Request for Proposals for the Fabrication and Installation of Exterior Graphic Trailer Wraps

This Addendum No. 2 shall be considered part of the RFP for the Fabrication and Installation of Exterior Graphic Trailer Wraps and is intended to correct, change, and/or add to the documents as described below. Please make sure to complete the *Addenda Acknowledgement* form included in the *Required Forms* (Exhibit B).

**Addendum No. 2 – RFP for the Fabrication and Installation
of Exterior Graphic Trailer Wraps**

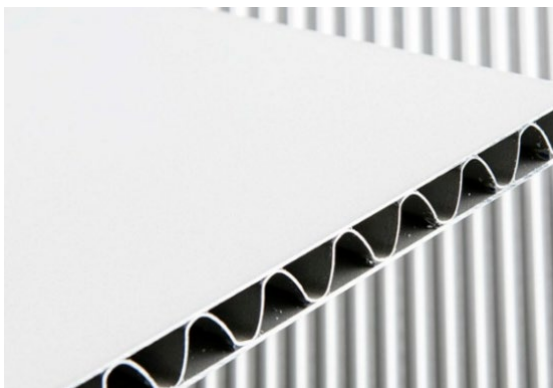
Question #17: *The whole of the front (8.5 x 9 feet) is to be covered with vinyl?*

Answer: Yes, the entire front panel will be covered with vinyl. The trailer sides will receive a partial wrap, while the rear portion of the trailer will remain uncovered, leaving the aluminum surface exposed. The SWACO logo will be applied to the exposed aluminum area on the rear section of the trailer.
